RECALL

#04V 030

Wire harness exposure to exhaust heat		
	A	B	C
	2002-2003 Firenze Type A with Ford Chassis	2002-2003 Firenze Type A with Workhorse Chassis	2002-2003 AVATAR Type A with Rear Radiator Freightliner Chassis
	Repair #1 - Reroute wire harness		
	Repair #2 - Replace wire loom cover and reroute wire harness		
	Repair #3 - Replace wire, wire loom cover and reroute wire harness		
	See Applicable Repair Instructions		
	See Applicable Repair Instructions		
	See Applicable Repair Instructions		
	* All ST times require an authorization prior to repairs being made. Call for assistance and estimate prior to completing work.		
	See Applicable Repair Instructions		
	See Applicable Repair Instructions		
	See Applicable Repair Instructions		
	See Applicable Repair Instructions

**Heat Shield Recall
NHTSA #04V-030
January 2004**

Fig. 2

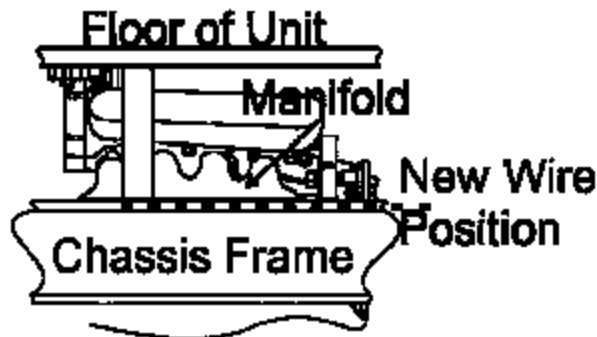
2. Move the wires from inside the frame rail and reposition them outside of the frame rail from the transmission forward of the engine. (Fig. 2)
3. Inspect the wire harness cover for any distortion caused by heat from the exhaust manifold. If no damage is discovered, proceed to step #6.

Fig.3

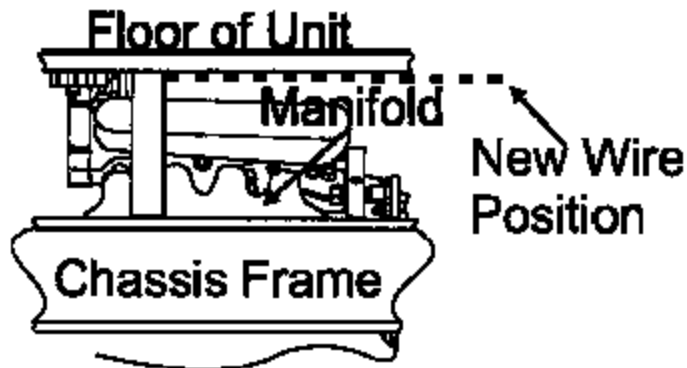
7. Clamp the wire harness to the floor of the unit with the p-clamps provided. (Fig.3)
8. Wire tie the wire harness to the frame rail with metal ties to hold it in place from the transmission tail shaft back. (Fig.3)
9. Wrap any existing wires that run parallel with the exhaust manifold with foil tape to protect them from heat.

Fig. 1

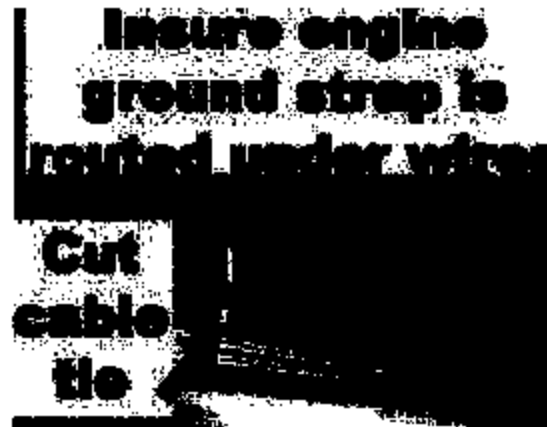
1. Locate the white plastic cable tie that attaches the Jayco wire harness to the chassis frame rail.
2. Cut the white plastic cable tie and discard. (Fig 1)

Fig. 6

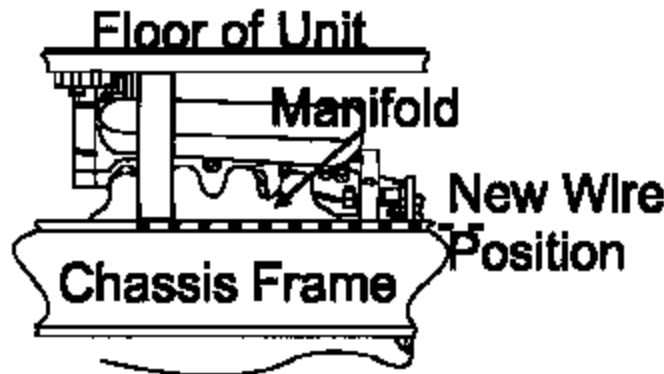
14. Install two (2) of the 12" x 12" precut insulation pieces on the wire harness routed on top of the frame rail beside the exhaust manifold. Some cutting may be required. (Fig. 6)

Fig. 5

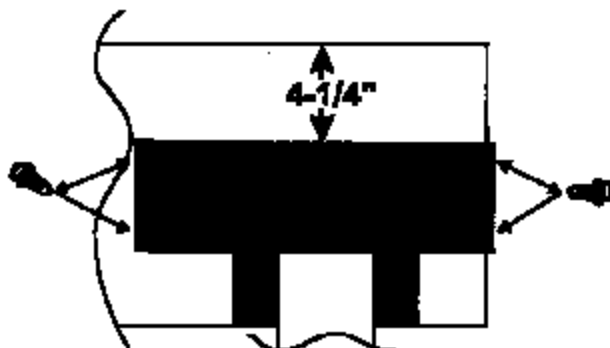
7. Place the heat shield at the dimensions shown. (Fig. 5)
8. With the use of three (3) self-drilling screws attach the heat shield to the top of the muffler shield. (Fig. 5)
9. From under the coach right behind the drivers side rear wheel, locate the front edge of the muffler shroud. The heat shield should be overlapping the front side of the muffler shroud about one inch (1"). With the use of three (3) self-drilling screws attach the heat shield to the front of the muffler shroud. (Fig. 6)
